PROPOSED S4.55(8) MODIFICATIONS LIST:

REVISION	DATE	DESCRIPTION	BY
A	20/12/23	S4.55 (8) MODIFICATION	MD,FB

VPM
9-11 VICTORIA PARADE, MANLY, NSW

DRAWING TITLE		PROJECT	
SECTION C		VPM	
SCALE	STATUS	NUMBER	REVISION
1:200	S4.55 (8)	A3.03	A

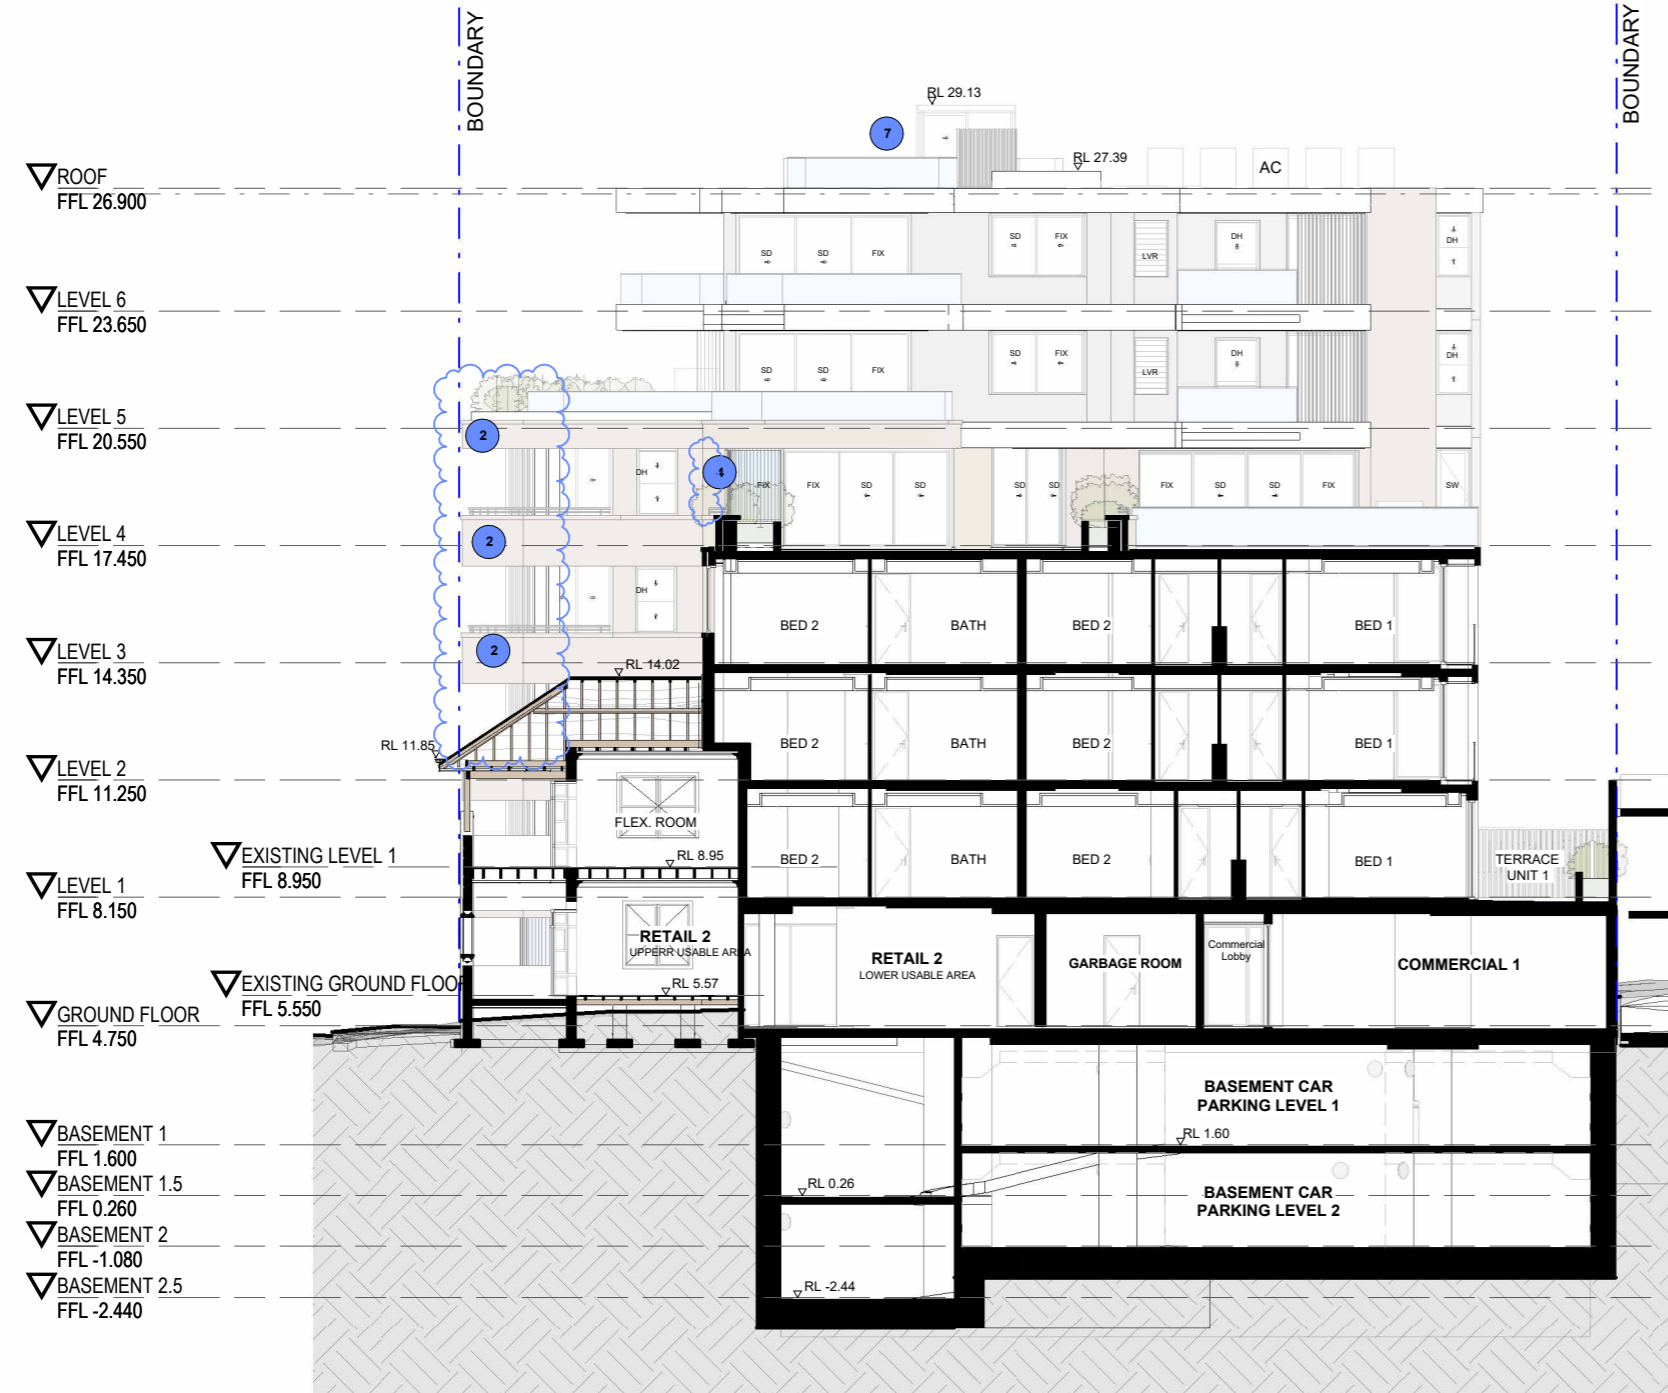
- Retail 1 on Ground floor has been pushed out to enhance the usable area and to suit new columns for balconies above.
- The front facade's angle has been adjusted to enlarge the front balconies and comply with ADG regulations of balcony size.

- Front balconies on level 1 and level 2 were extended to the north east to align with the approved balconies above to avoid looking 'top-heavy' and unbalanced.

- Level 4 brick wall shifted to align with adjacent brick walls.
- Cladding colour proposed to be off-white to visually lighten the bulk of the upper floors.

- Allocation of 1 bicycle space per unit in large storage cages in lieu of separate bicycle parking to satisfy the intention of condition 43D.
- Private roof terrace introduced to improve amenity of unit 14. The glass stair enclosure is not readily visible from the street and has no real impact on privacy, bulk or overshadowing.

- Increase in width of high-light windows to improve ventilation and natural lighting in the bedrooms with no privacy impacts.
- Minor adjustment to the GFA due to the above– still less than LEC approved FSR 3:1.

- Window heads have been lowered to 2.58m to fit services
